## WATERVIEW CONNECTION

#### Supplementary Section 42A Report Groundwater and Settlement

Report prepared for:  
**ENVIRONMENTAL PROTECTION AGENCY**  
(Ministry for the Environment)  
On behalf of:  
**WATERVIEW CONNECTION BOARD OF INQUIRY**

Report prepared by:  
**EARTHTECH CONSULTING LIMITED**  
P O Box 721, Pukekohe  
Phone: 64-9-238 3669

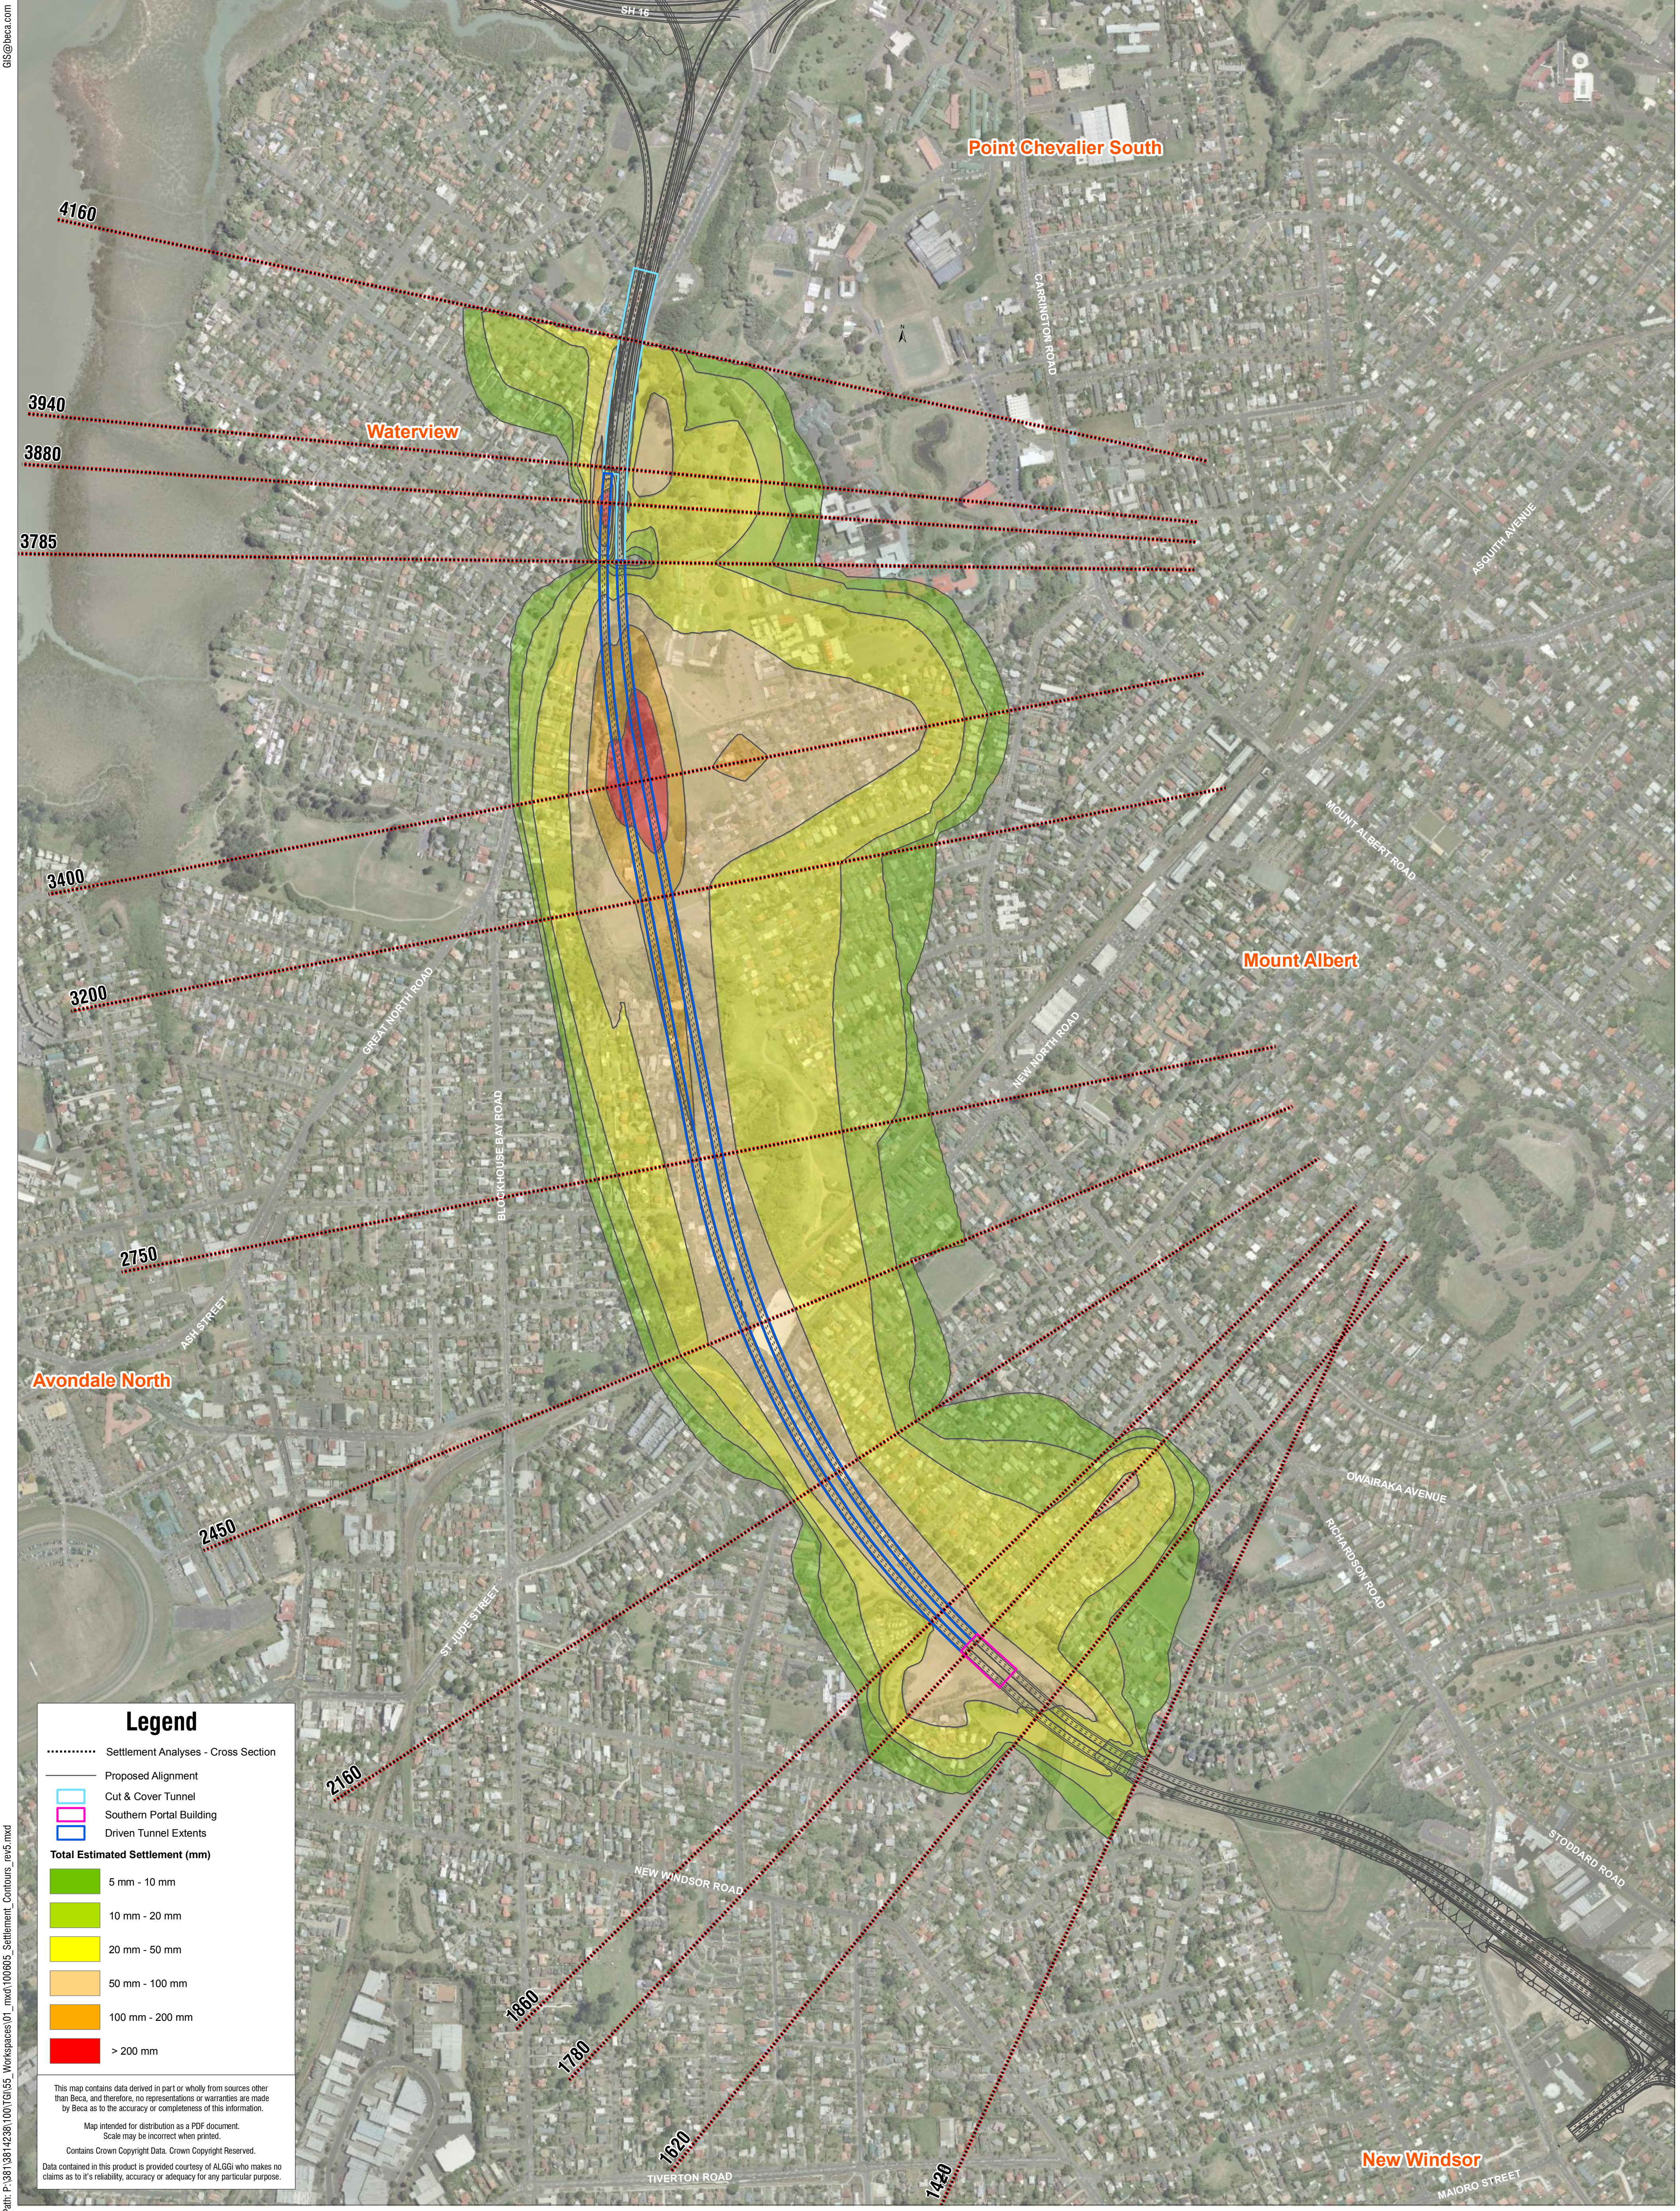
Figure E14 provides the Applicant's best estimate predictions and this plan should be used as the base plan for the assessment of effects. This provides certainty to all parties.

Groundwater drawdown is the principal factor in determining the magnitude and extent of settlement effects. If the Water Permits are granted, it is recommended that permitted total settlements be no greater than that shown on Figure E14 (Appendix A).

Figure E14 is truncated at the northern and southern end of the works (Ch4160 and Ch1420m respectively). Drawdown and settlement effects may extend beyond these limits and Figure E14 should be adjusted accordingly.

The final paragraph has been added to provide alert and alarm levels based on Figure E14. This provides all parties with confidence that any changes to the predictions on E14 will be noted and dealt with appropriately. The alert level suggested is 75% of the E14 levels with the alarm level at 100% of the E14 levels.

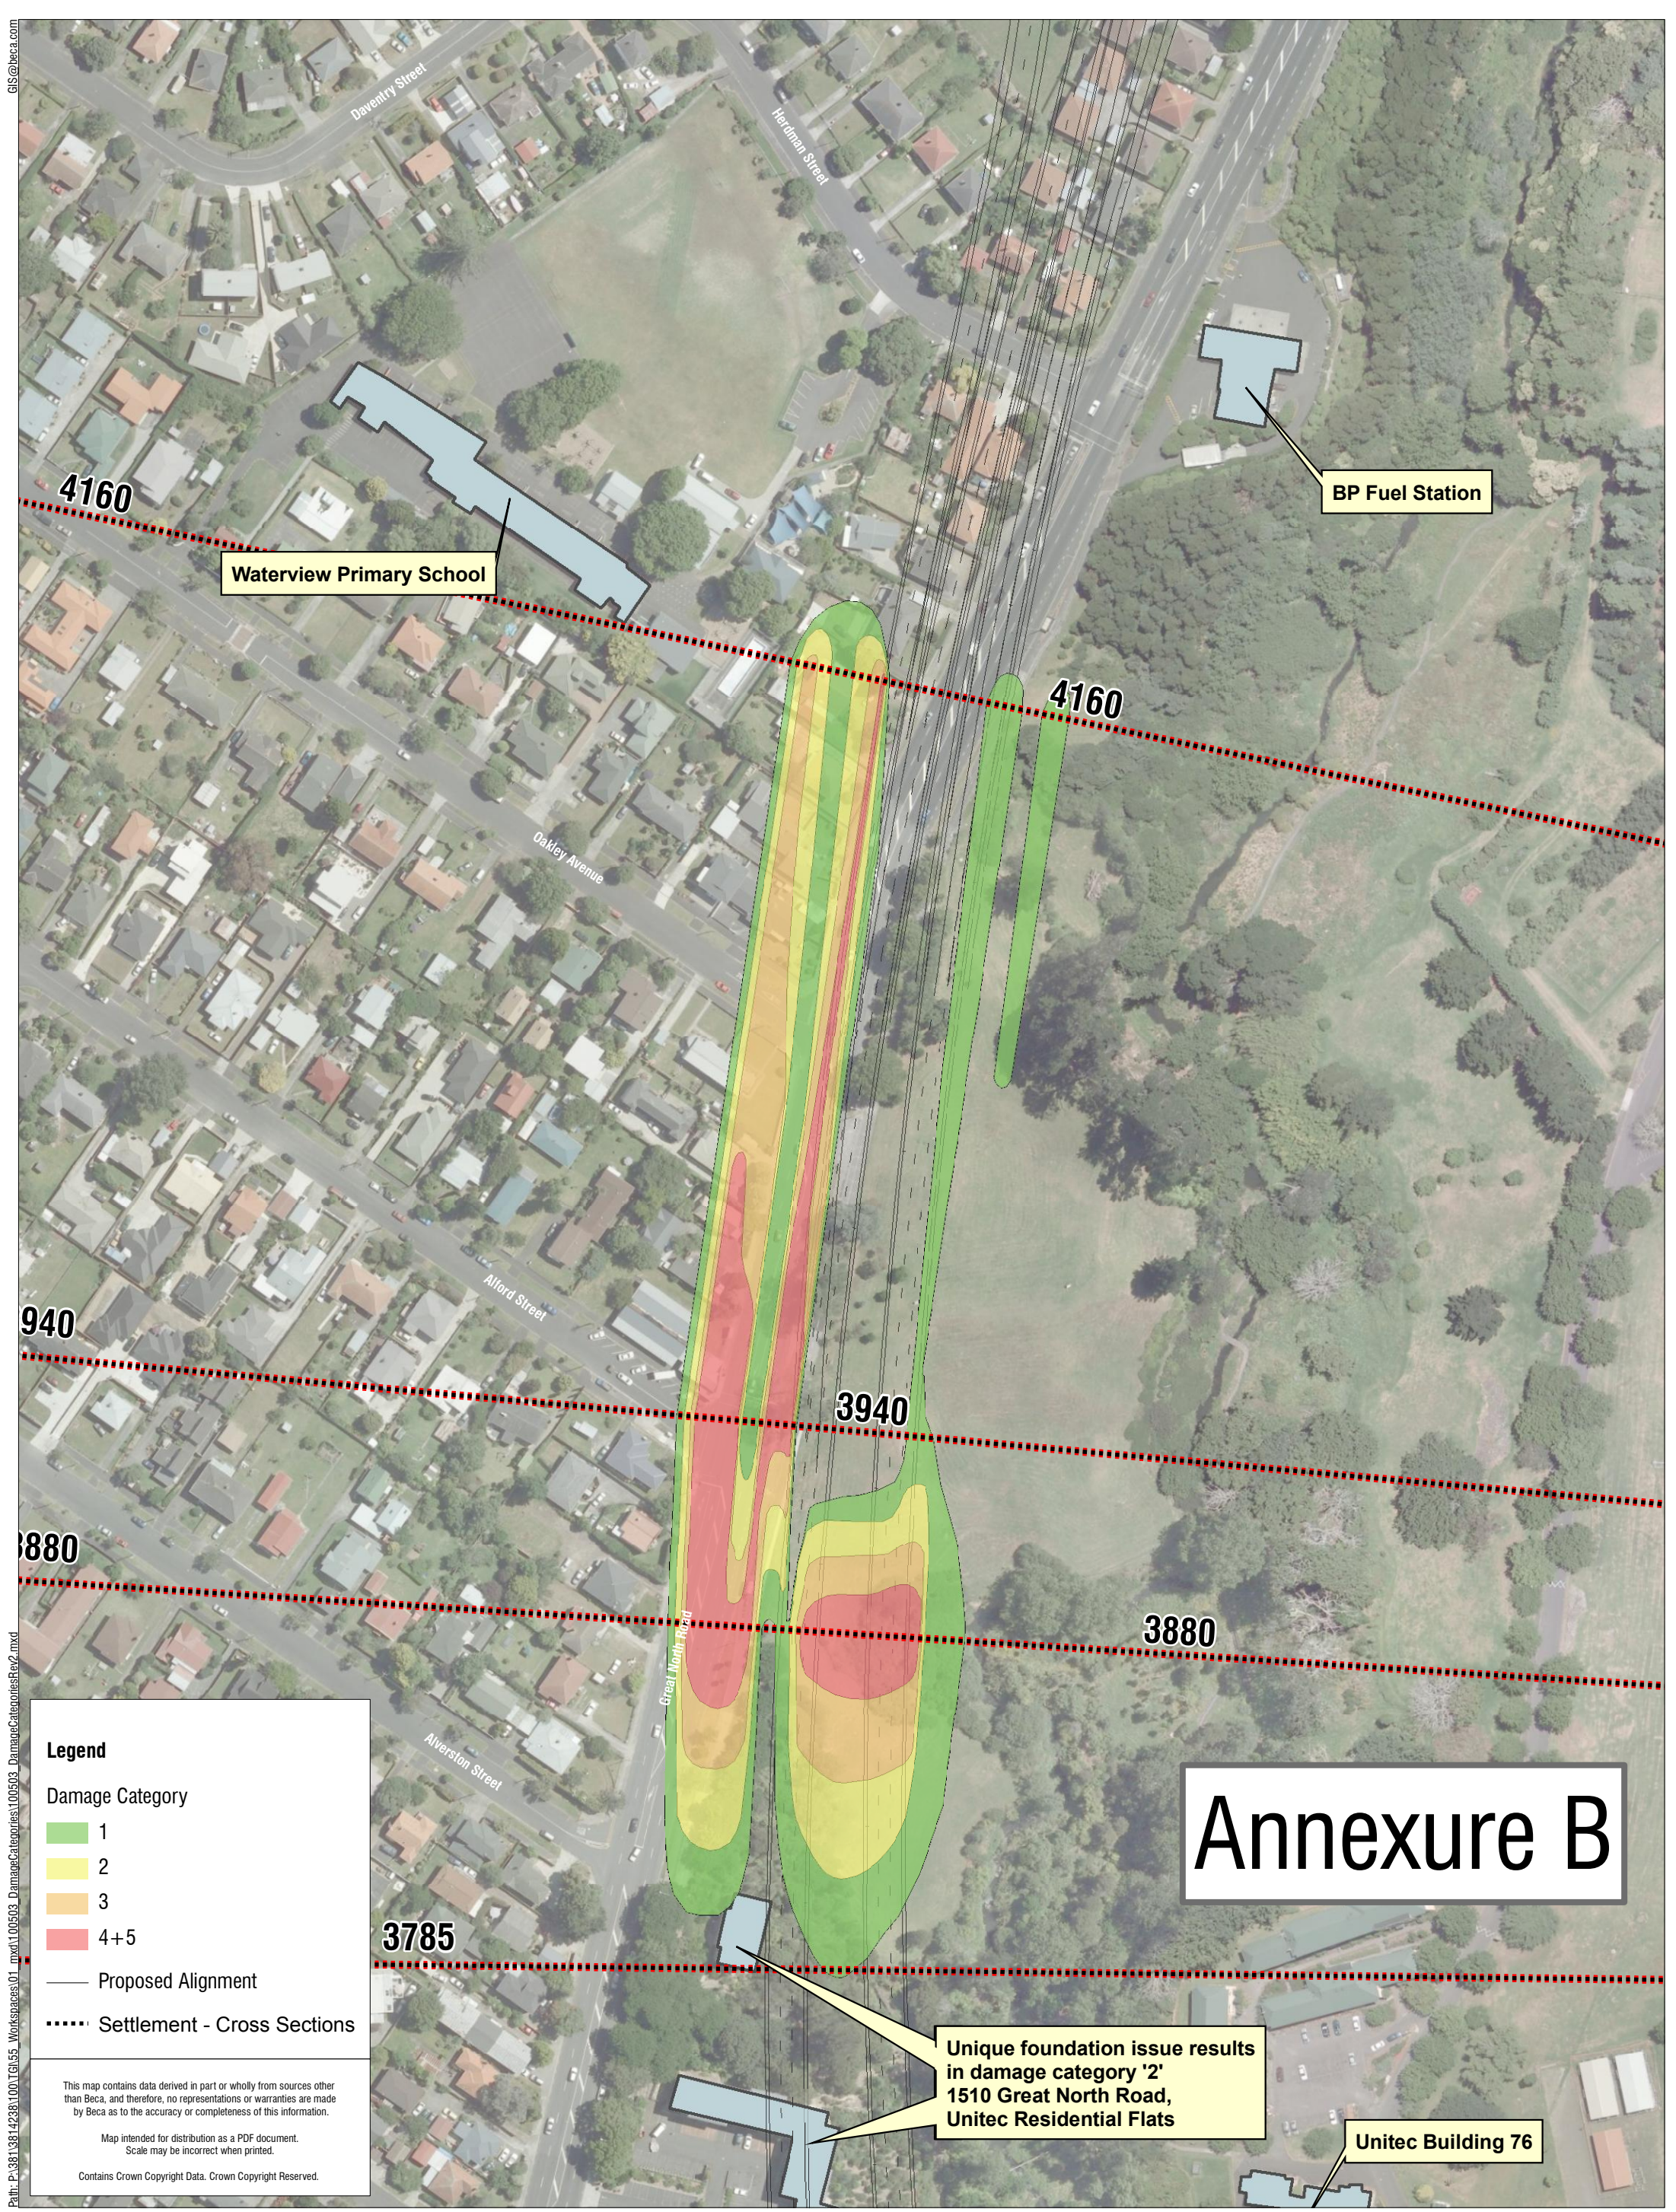
These building categories have in turn been overlaid on site plans to show where the tunnelling and/or excavation works could result in building damage. These plans are provided in Figures G1, G2 and G3 (attached in Appendix A). These provide the best assessment of areas where possible building damage may occur.

Mr Alexander's amended condition requires an updated version of the settlement prediction (Figure E14) and the building damage categories (Sheets G1, G2 and G3) prior to construction. The outcome of this update is not certain and may lead to an increase or decrease in the effects. This leaves affected parties and the Hearing Committee with no certainty that the effects will be no more than currently predicted. Adding the following paragraph to S.1 provides more certainty.
